To: All Takers of Contract Documents for the Subject Project
From: **FST ENGINEERS, Inc.**
Subject: Suffolk County Department of Public Works
Sanitation Division
SD No. 3 Bergen Point Wastewater Treatment Plant
Screening Room Odor Control
Capital Project No. 8170 - **REBID**

We are enclosing **Addendum No. 2** to all who have taken out Contract Documents for the above mentioned Contract. Addendum No. 2 includes:

ADDENDUM No. 2 - ATTACHMENT C

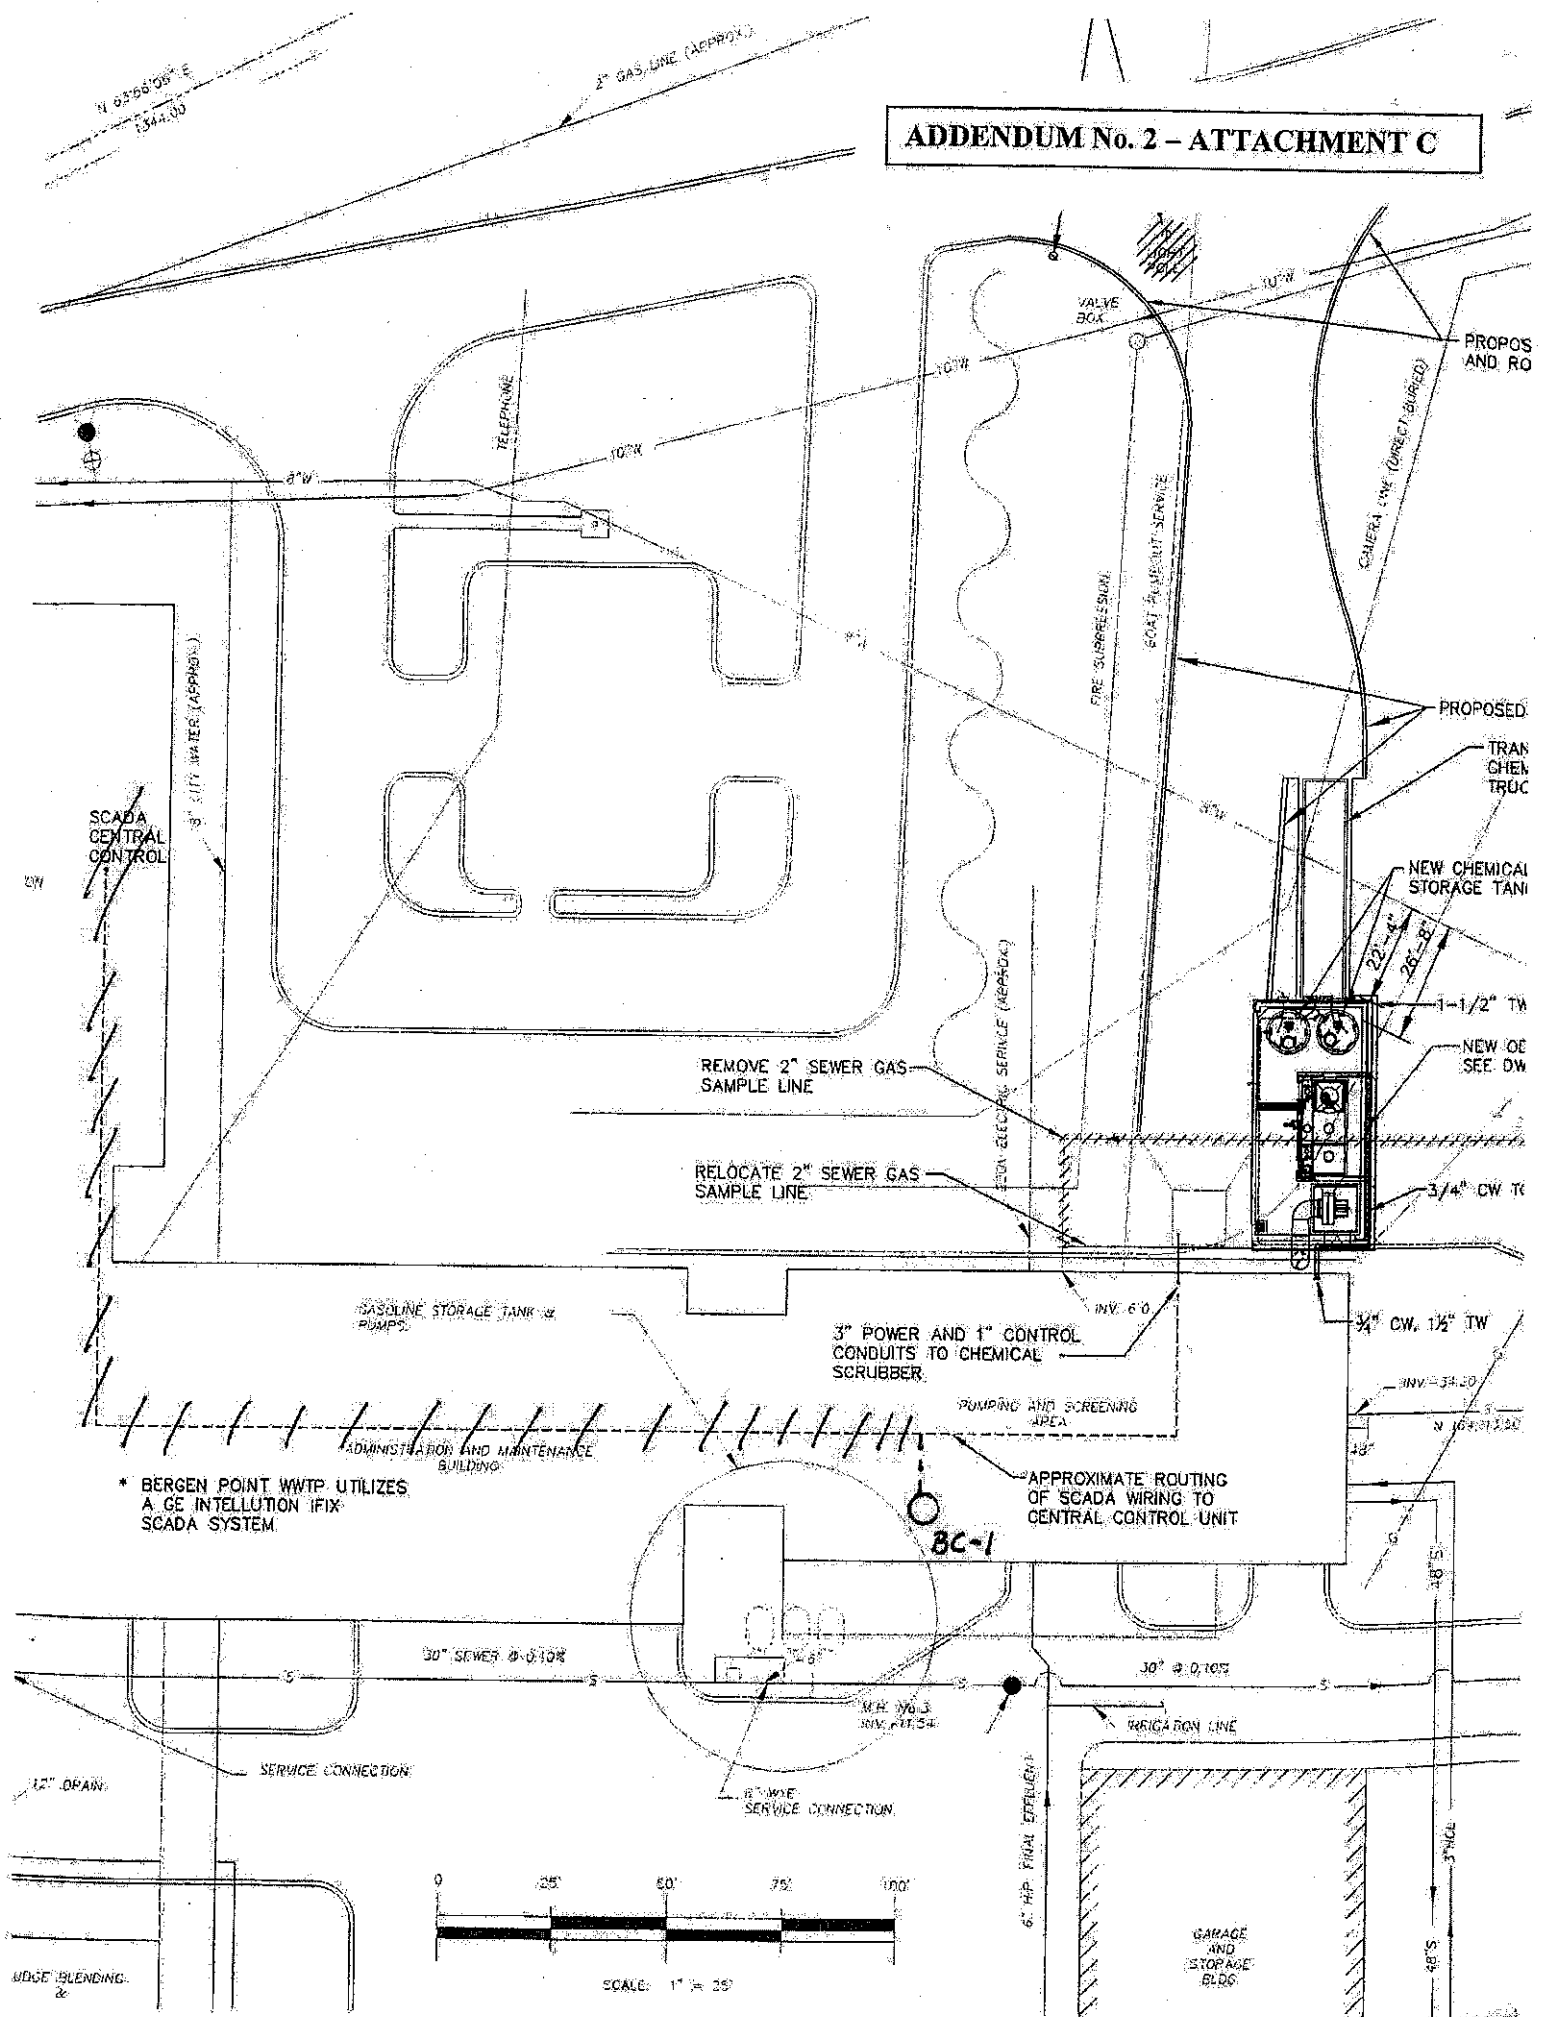
1. For the 4” PVC DRAIN, add the following note: “Provide a minimum pitch/slope of 2% and 5’ minimum cover.”
2. With reference to the ROUTING OF THE SCADA WIRING, see ATTACHMENT C (2

pages). The control conduit/SCADA wiring is to be terminated at cabinet panel BC-1. Also - the actual penetration of the 3" power and 1" control conduits shall be determined in the field.
